## #382500 MICRO SERVO SAVER

### When Using With XRAY M18:

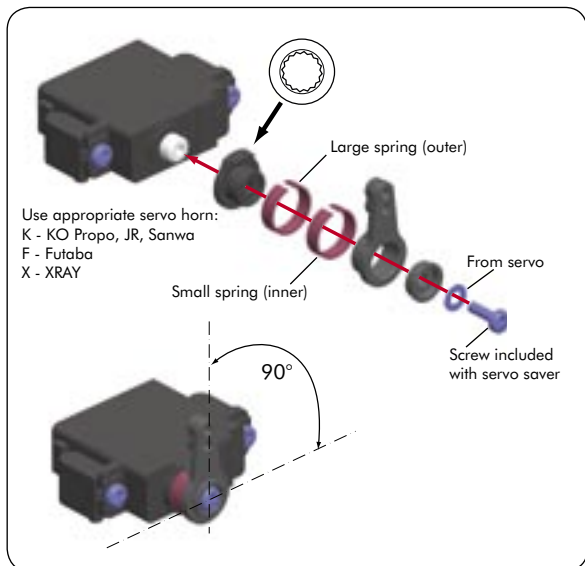
When using stock 12° front upper arms, the servo saver may touch the steering block when the wheels are turned. We suggest removing a small amount of material from the steering block as shown. This issue does not occur when using the optional 6° front upper arms.
